BSTHD1043 Radial Arm Saw Motor Starter is replaced by BSTHD1045

BSTHD1044 Dust Collector Motor Starter is replaced by BSTHD1046

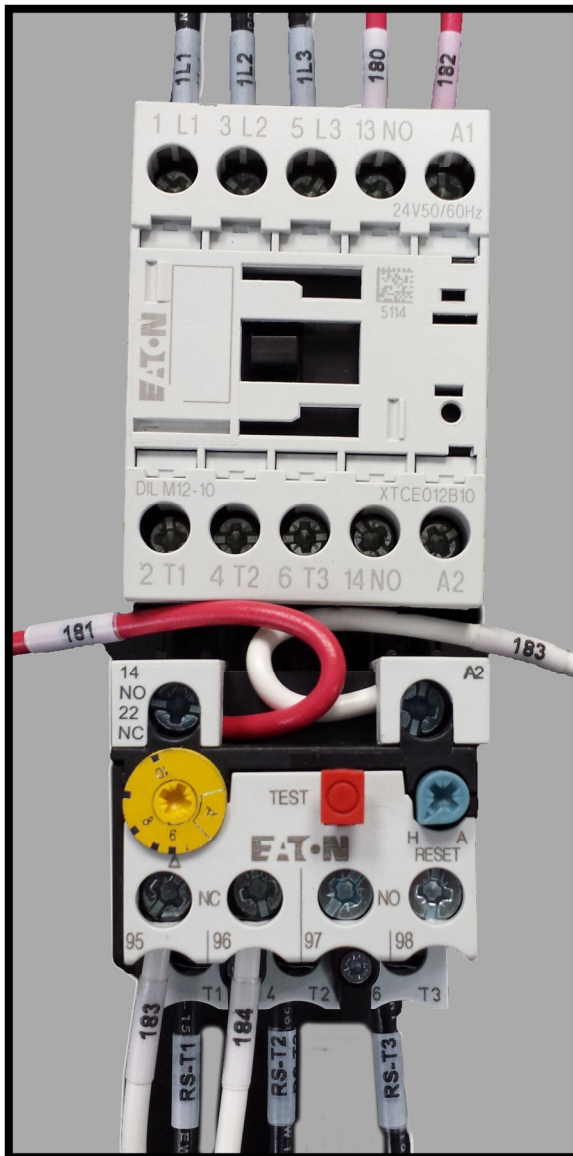
BSTHD1045 and BSTHD 1046 are shipped as two components that will need to be assembled in order to be wired into the panel. Wiring and assembly shown below:
